The Team have submitted a detailed document to the Marine Management Organisation in opposition to the seaweed farm at Port Quin. Our responses are technical and evidenced, as requested, and conclude that this proposal is a dangerous folly which would cause long term damage to the bay and its wildlife, would pollute the sea, put human lives at risk, and ruin the seascape. We have also commented (at length) on the applicants' misrepresentation of research studies and on the scale of the infrastructure. Crucially, we debunk the assertion in the Document that the sea bed in the bay is "coarse sediment" or "very coarse", "coarse sediment with pebbles", "coarse substrate", "coarse (gravel)". "Coarse sediment" is repeated over 75 times in the Document ("consultation" only appears 13 times, by comparison). It's not "coarse sediment", it's sand. Sand is a critical habitat for prey species foraged by our marine mammals like seals and harbour porpoise (protected under Special Area of Consultation directives), and the Red Listed puffins, guillemots and razorbills nesting on the Moulds. Coarse sediment, or gravel, is not so critical a habitat. Claiming that the sediment is coarse is fundamenta

AIS data for Vessel type Cargo between January 2012 and present day

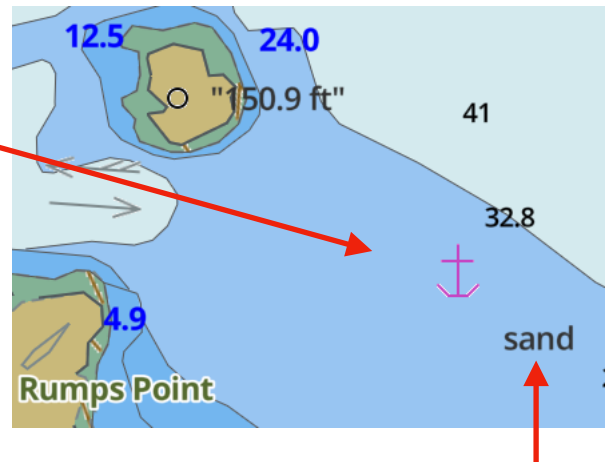
Port Quin Bay is a designated Safe Anchorage area. It is sheltered enough for large cargo vessels to wait out rough weather, and many do. The applicants reckon, however, that these vessels in peril *"are not specifically utilizing the safe anchorage point each time but are either transitioning through (to where?) or temporarily anchored within the wider bay area"*, and that *"The next closest designated safe anchorage is 2 miles away at Steppers"*

[sic] Point". The image on the left shows cargo vessels utilising all anchorage in the area over a 12 year period.
